ECE/TRANS/WP.29/2009/73
9 April 2009

Proposal for Corrigendum 1 to global technical regulation No. 2
(Worldwide harmonized Motorcycle emission Test Cycle (WMTC))

Submitted by the Working Party on Pollution and Energy */

Figure A13-1: Example of a gearshift sketch

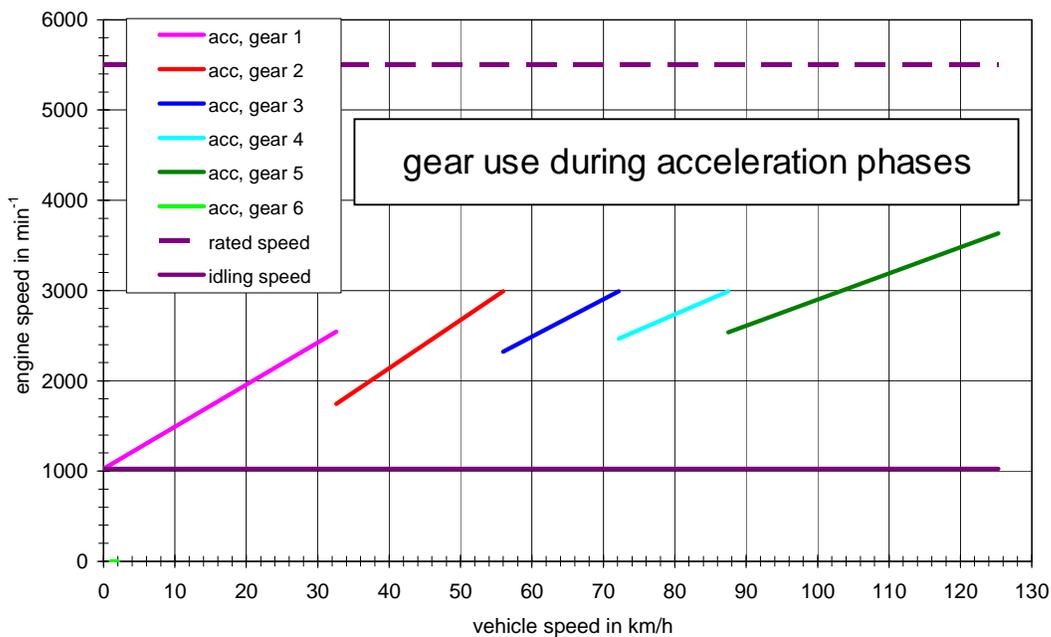
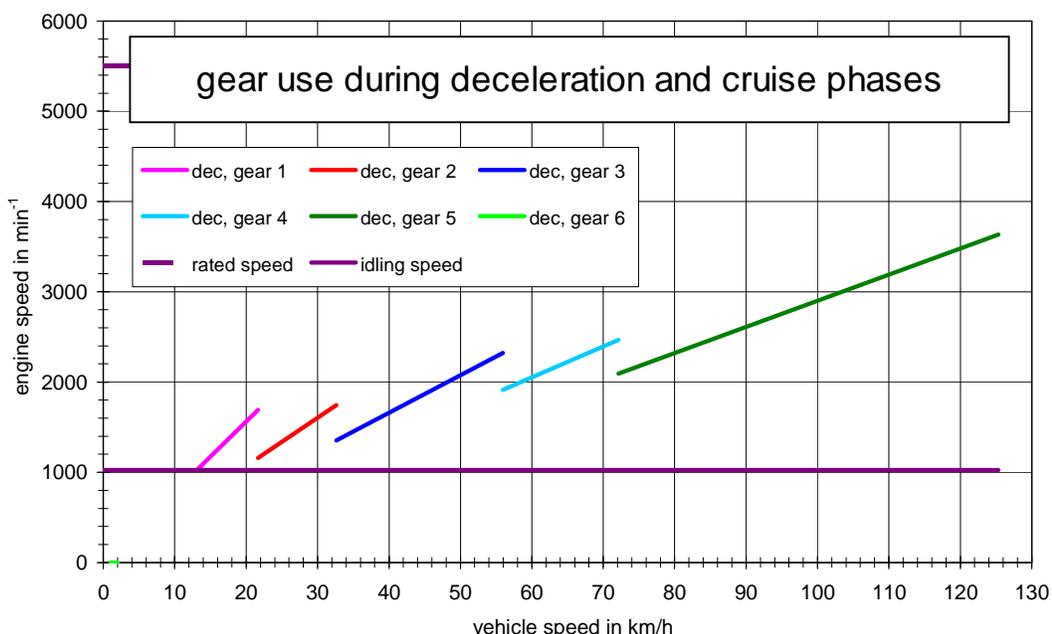
Figure A13-1 shows an example of gearshift use for a small vehicle.

- (a) The lines in bold show the gear use for acceleration phases.
- (b) The dotted lines show the downshift points for deceleration phases.
- (c) The cruising phases the whole speed range between downshift speed and upshift speed may be used.

In case of gradually increase of vehicle speed during cruise phases, upshift speeds ($v_{1 \rightarrow 2}$, $v_{2 \rightarrow 3}$ and $v_{i \rightarrow i+1}$) in km/h may be calculated using the following equations:

In order to allow to the test service more flexibility and to assure driveability the gearshift regression functions should be considered as lower limits. Higher engine speeds are permitted in any cycle phase.

Figure A13-2: Example for modified phase indicators

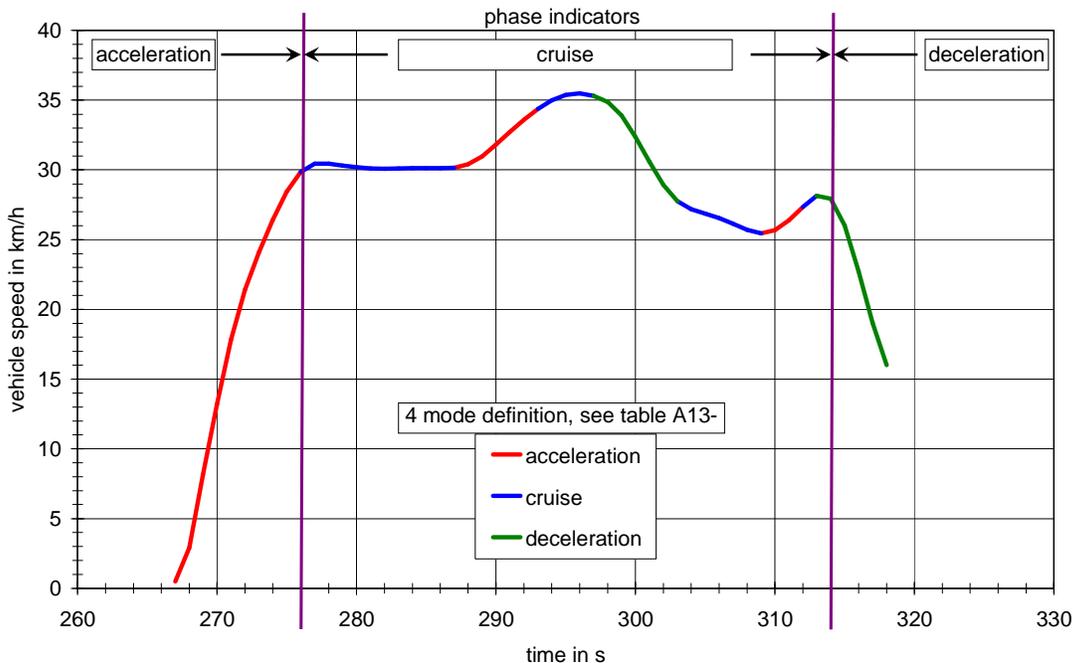
The indicators were then modified in order to avoid frequent changes during relatively homogeneous cycle parts and thus improve the driveability. Figure A13-2 shows an example from cycle part 1.
